Model: Neptune-C1		Date: 3-Jun-04	No.: MB125001
Modified Article: Parts Catalog		Prepared by: F.Noguchi	
From: 2nd Tech. Support Sec. Service Support Dept.			
Reason for Modification:	☒ Parts catalog correction ☐ To facilitate assembly ☐ Part standardization	☐ Vendor change ☐ To improve reliability ☐ Other	☐ To meet standards ()

Please apply the following P/N and description revisions to your Parts Catalogs (new parts below used from beginning of mass production).

3.

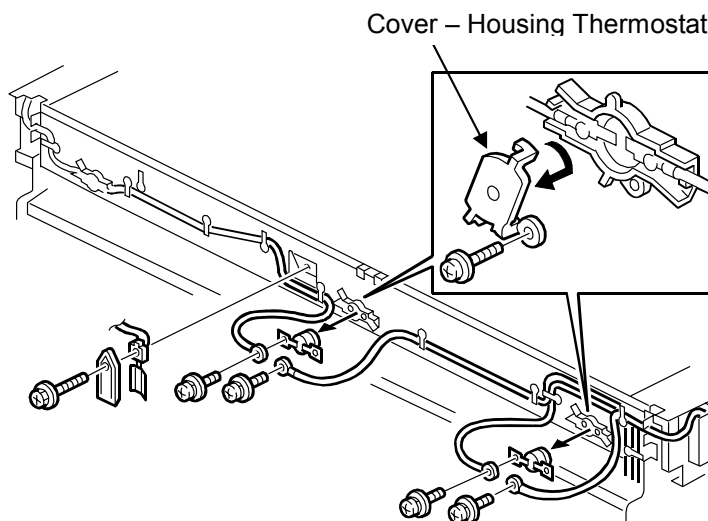
New part number	Description	Q'ty	Int	Page	Index	Note
B1044086	Cover – Housing Thermostat	0 - 2		33	19

Change: The cover for the thermostat was added.

Reason: To facilitate assembly in the field.

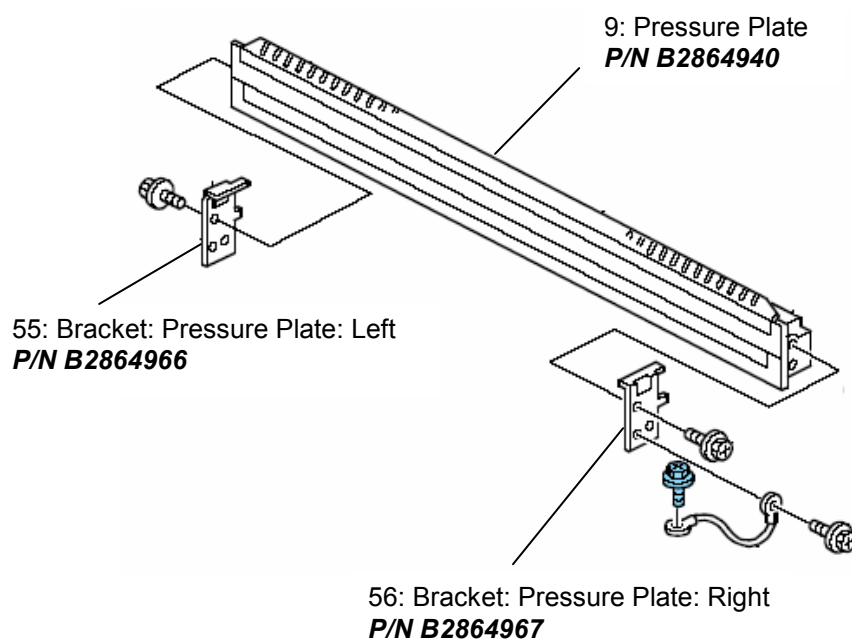
Old part number	New part number	Description	Q'ty	Int	Page	Index	Note
B1254850		Platen Plate	1 - 1	X/X	13	9	*1
	B2864940	Pressure Plate					
B1254855		Bracket: Platen Plate	2 - 0	X/X	13	2	*1
	B2864966	Bracket: Pressure Plate: Left	0 - 1	X/X	13	55	*1
	B2864967	Bracket: Pressure Plate: Right	0 - 1	X/X	13	56	*1
B1254857		Sheet: Guide: Pressure Plate: Right	1 - 0		13	53	*1
B1254858		Sheet: Guide: Pressure Plate: Left	1 - 0		13	54	*1
B1254675	B2864675	Transport Roller: Original Exhaust	1 - 1	X/X	15	15	*2
B1254696	B2864696	Guide Plate: Original: Rear Lower	1 - 1	X/X	15	16	*2

Note: The interchangeability is O/O as a set.

Change/ Reason: Due to parts standardization with Neptune-C2
